| Project | IEEE 802.16 Broadband Wireless Access Working Group < http://ieee802.org/16 > | |
| Title | Space-Time Codes for 3 Transmit antennas for the OFDMA PHY | |
| Re: | 802.16e/D4 | |
| Purpose | To propose 3 transmit antenna space-time codes for 802.16e/D4. | |

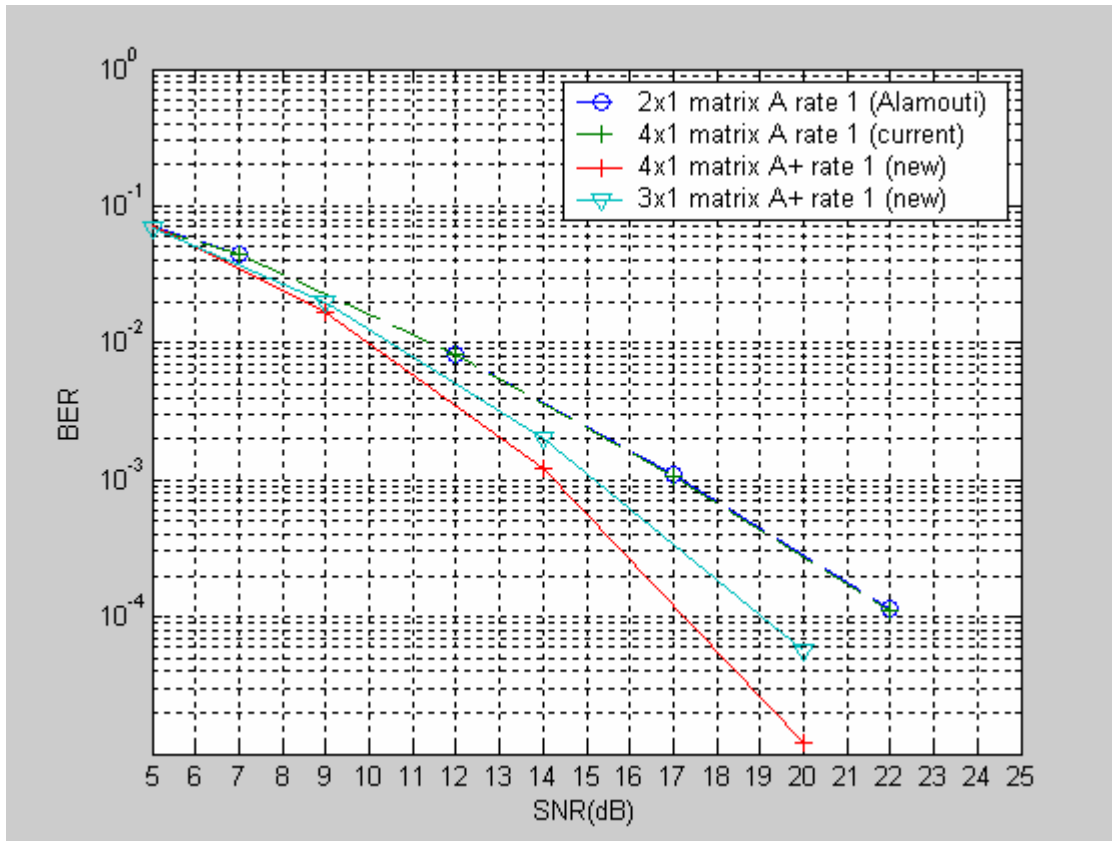
The uncoded BER for a flat, Rayleigh channel is included below, where the channel is assumed to be quasi-static over 2 OFDMA symbols. These codes are sent over 2 OFDMA symbols, and over 2 subcarriers. Please refer to [3] for details of 4x1 matrix A+.

Figure ccc - Pilot allocation for 3-antenna BS for the optional FUSC and the optional AMC zones

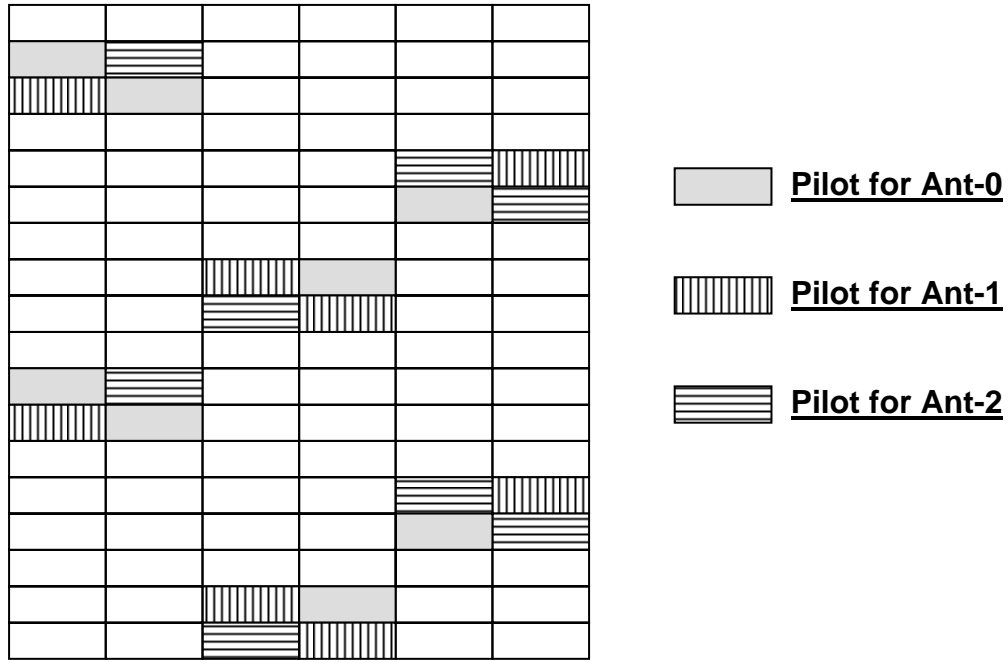
For 3-antenna BS, pilot allocation pattern shall first be changed as in the 2-antenna BS case, and then the neighboring two subcarriers shall be further allocated as pilots. This is shown in Figure ccc.
